Intel Bay Trail-M Platform Block Diagram

Quanta Computer Inc.
PROJECT : NL6

Size Document Number Rev 1A
Intel Block Diagram
Date: Friday, April 25, 2014 Sheet 1 of 41

| | Valley 6/9 (USB/LPC/I2C) | 1A |

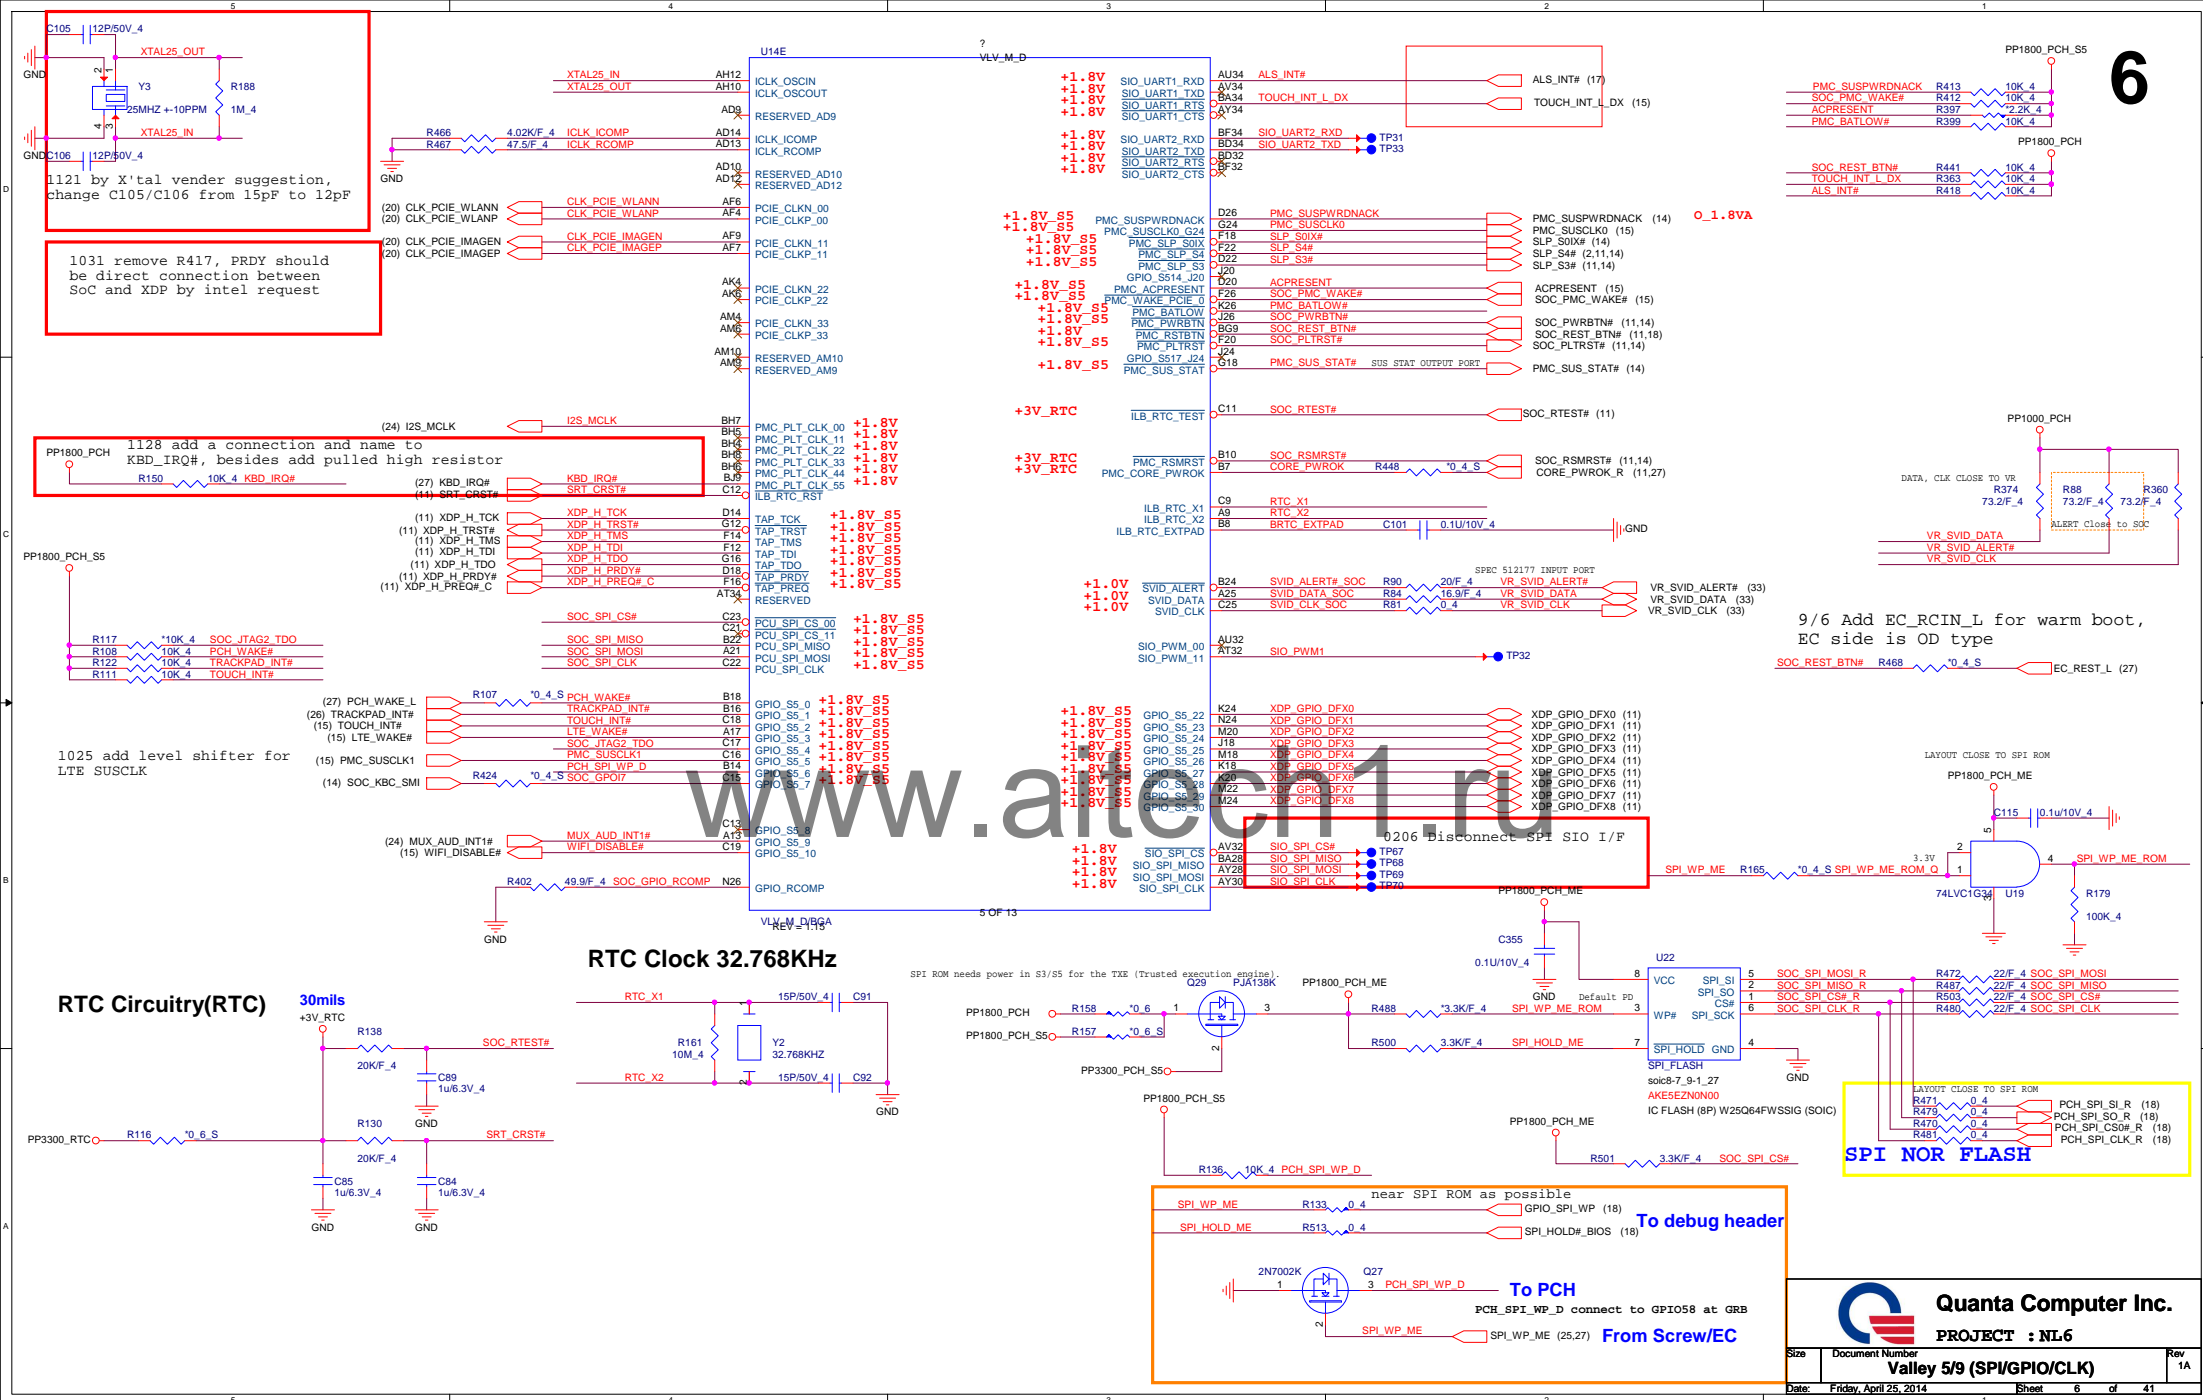
Proto1/1.5 stage use H2G & H4G
1212 add new RAMID 101 for single channel SKU

0220 R392,R389,R71,R65 need always to be stuffed even if w/o TS SKU

1101 add option BOM R446,R449 for
EC CLK for power saving by Intel
request

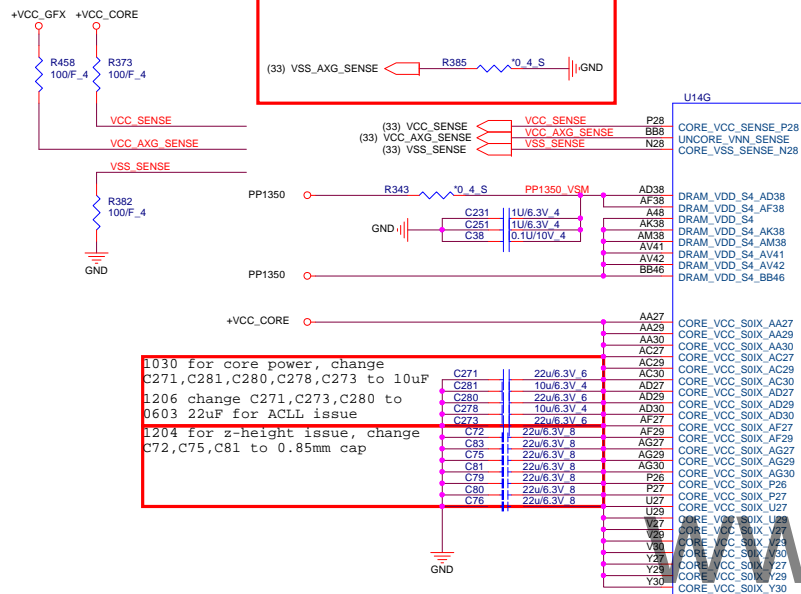
1031 for layout suggestion by intel, VSS_AXG_SENSE didn't connect to VSS_SENSE, will connect the GND via near VCC_AXG_SENSE
1031 for layout, add 0hm between GND and VSS_AXG_SENSE

REV = 1.15 1031 remove TP44 and TP35 for GND vias adding

| | Valley 7/9 (Power 1) | 1A |

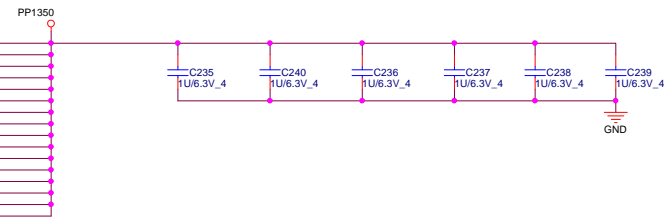
1030 for Gfx power, change C266,C289,C290 to 10uF and add 2 caps 10uF
1206 change C266,C311,C315 to 0603 22uF for ACLL issue

1030 change C60 power netname for layout

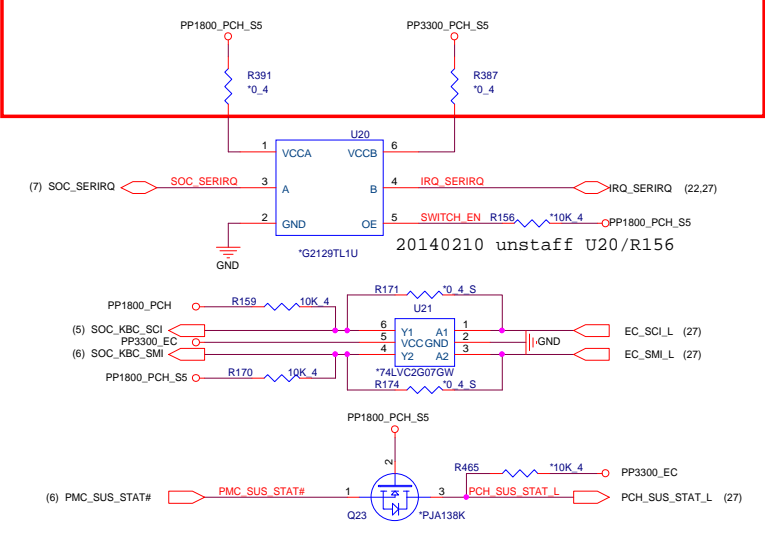
9/6 EC table says SERIRQ is OD pin, reserve for debugging
 1128 remove R166, because SERIRQ of TPM needs 3V
 1128 reserve 0 ohm R387/R391 on VCCA and VCCB for debugging
 20140210 unstuff R387/R391

PWRON SEQUENCE

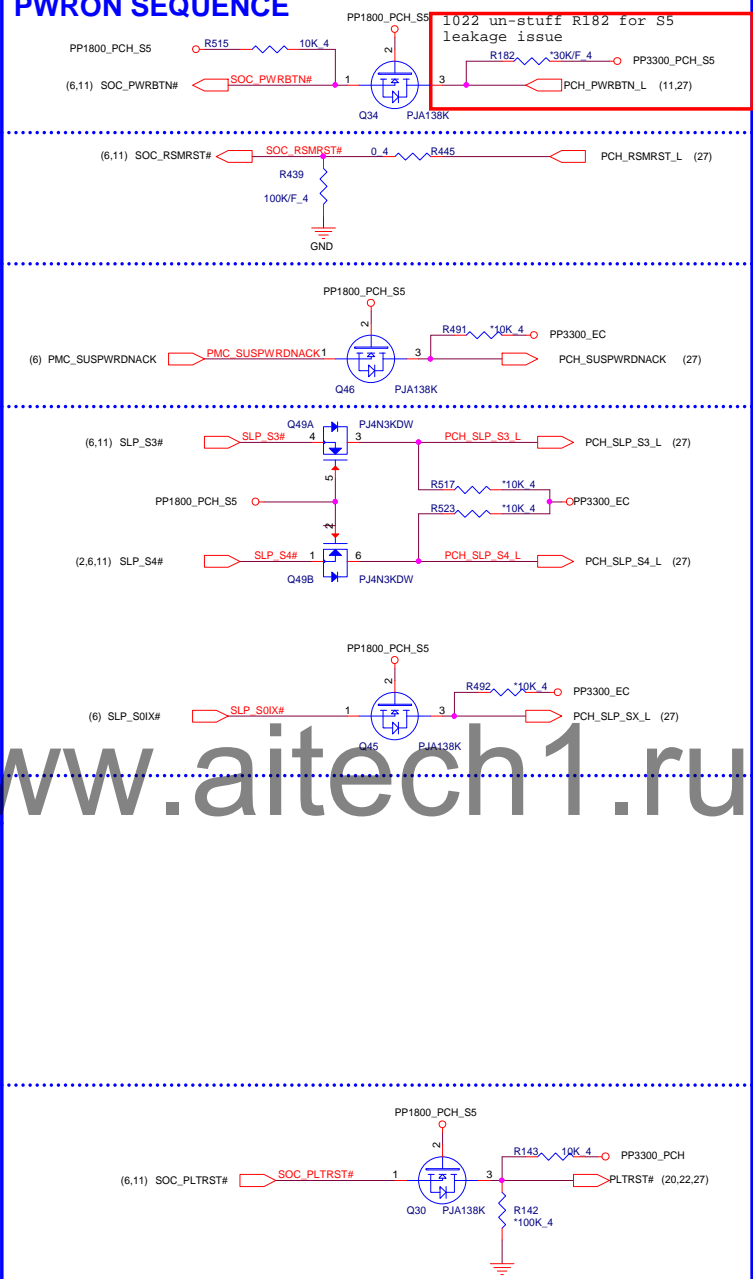
0128 change power rail of Q35,Q36,Q37,Q44 from PP1800_PCH_S5 to PP1800_PCH for PP1800_PCH leakage issue in S3 mode

0206 remove/delete SPI_SIO Interface, Q35,Q36,Q37,Q44,R486,R484,R485,R483,R426,R429,R427,R428

SD/MMC CARD READER CONNECTOR (MMC)

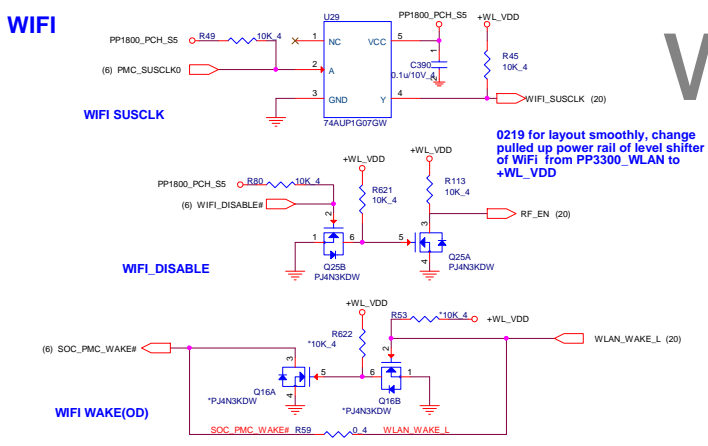
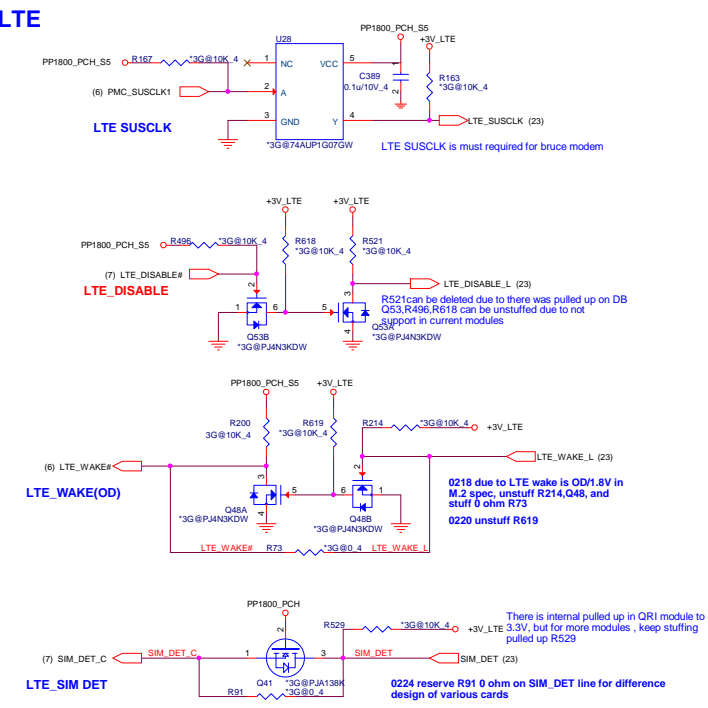
1205 the damping of SDIO change to 0 ohm by Intel request
 1205 add PU for SDIO WP by Intel request
 1205 R551 changes to 1K to isolate SD socket and servo/SoC
 1205 SD3_WP is 1.8V power rail in SoC, change external Pulled up power well of SD3_WP to 1.8V power

1202 add C285 for U18 input inrush current

1101 correct C351 footprint

1211 add pulled up resistors on SDIO data/cmd lines
 1212 all pulled up resistors of SDIO data/cmd to be un-stuffed

GOOGLE Debug Port(MPC)

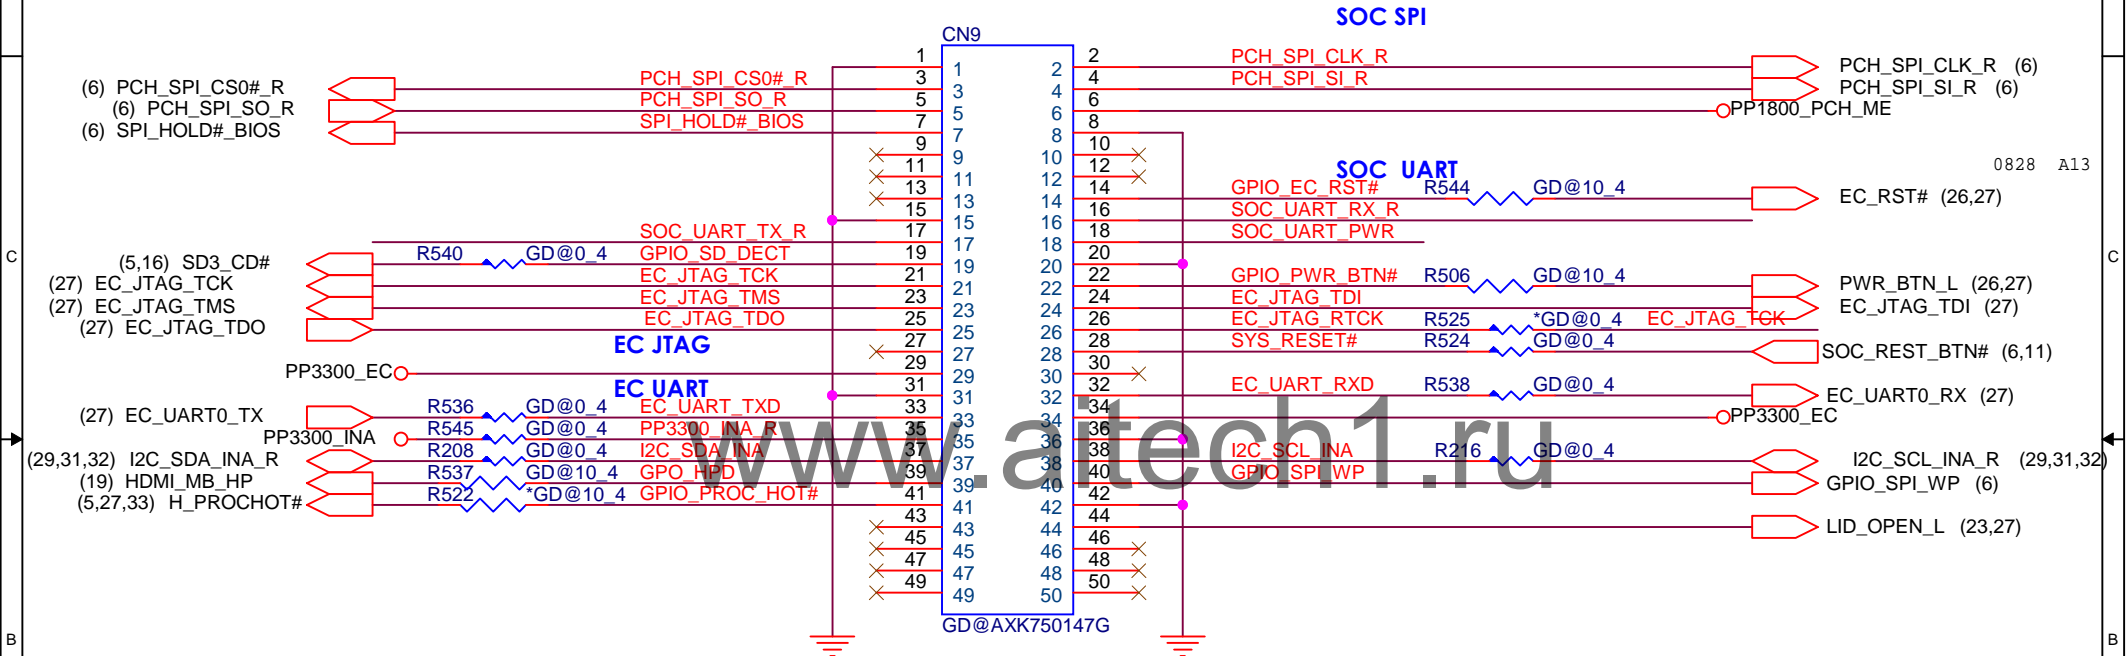
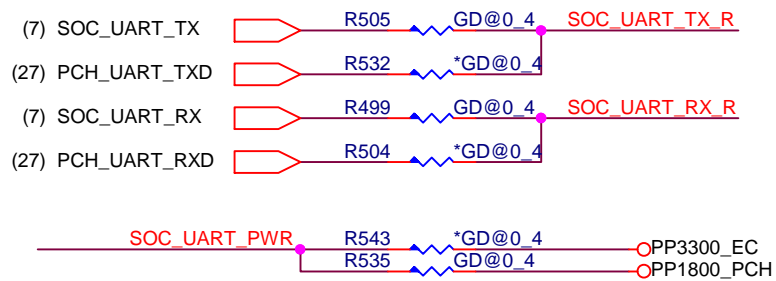
1021 change footprint and PN

9/6 using optional instead of level shifted, default is from SoC

9/13 add pull up

K/B (KBC)

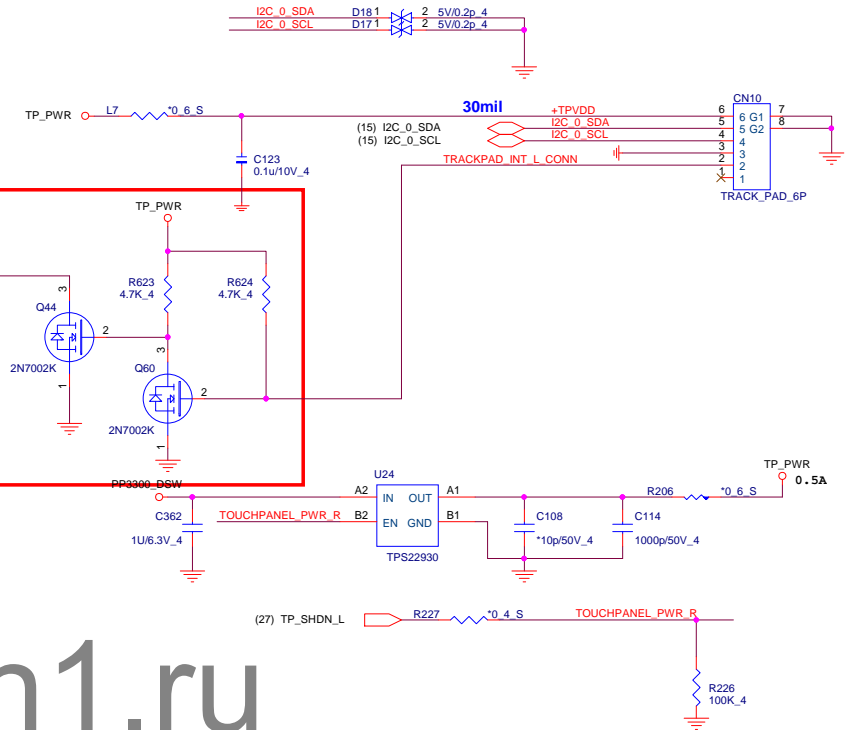
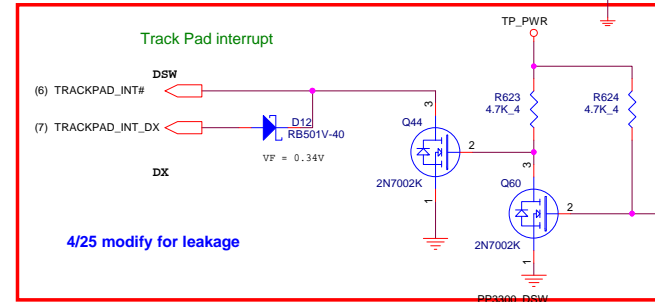
20140127 Change KB CONN for ME require

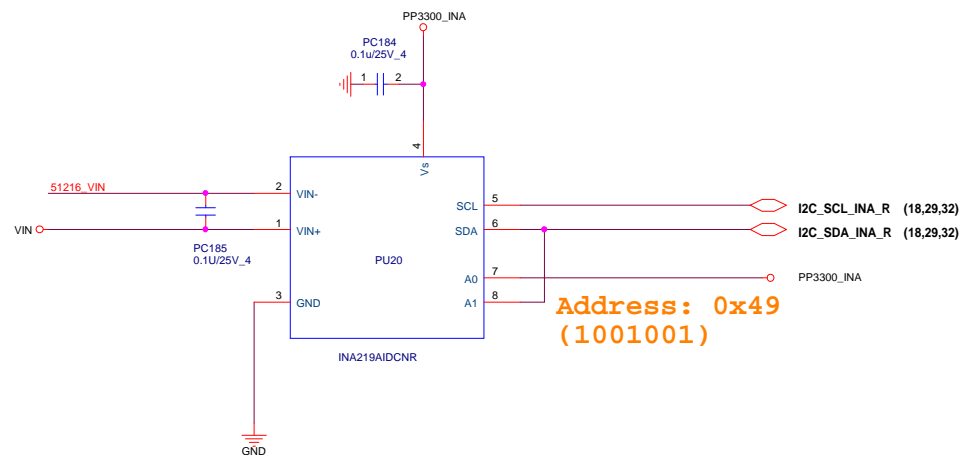
0417 PC13 change to 10uF ,
add 2x10uF PC215 , PC216

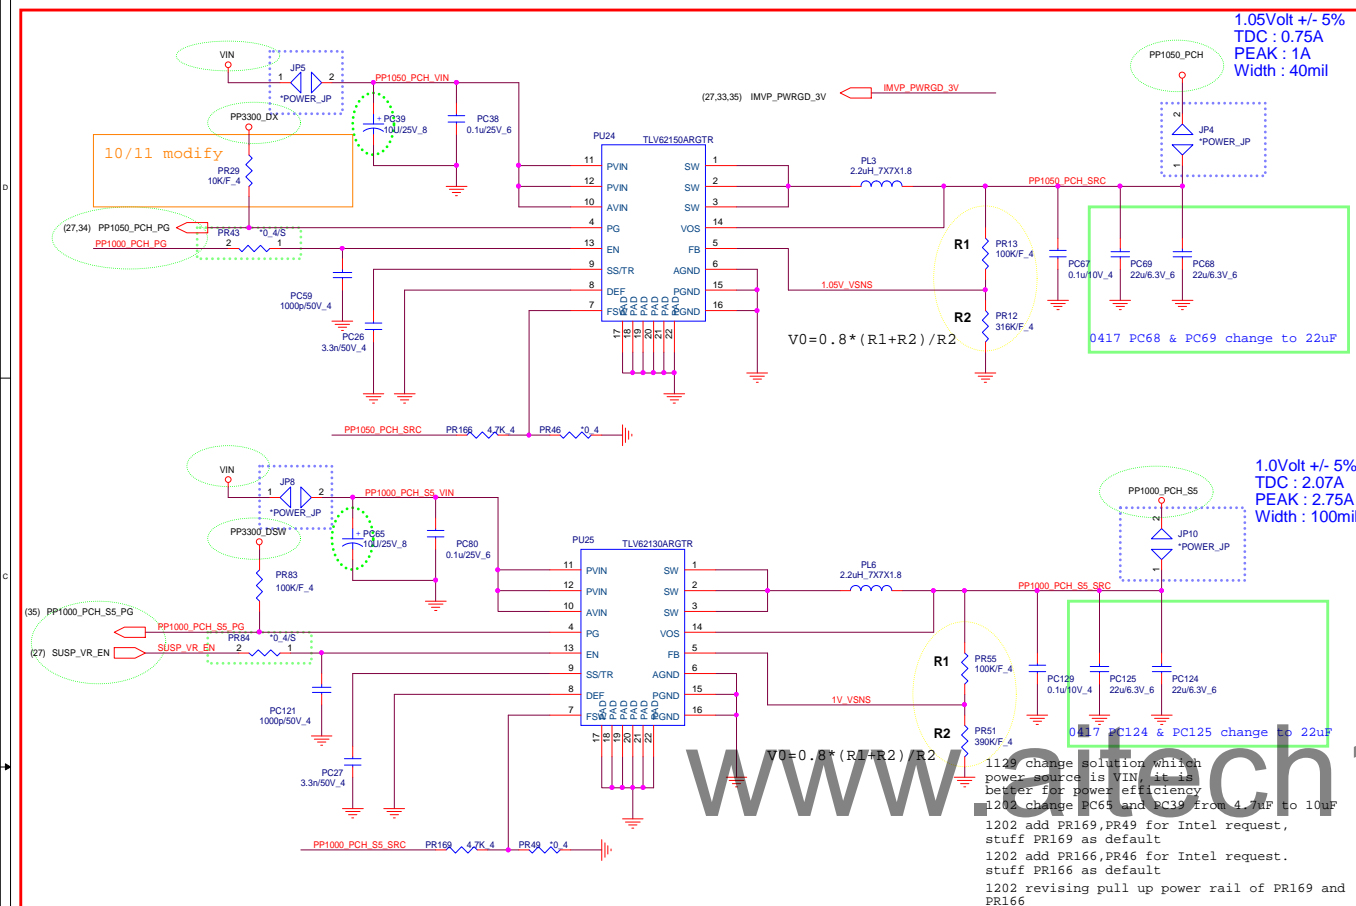
1129 PP1000_PCH changes from convert to power MOSFET type for power efficiency improvement

0417 PC87 &
PC88 change to
10uF
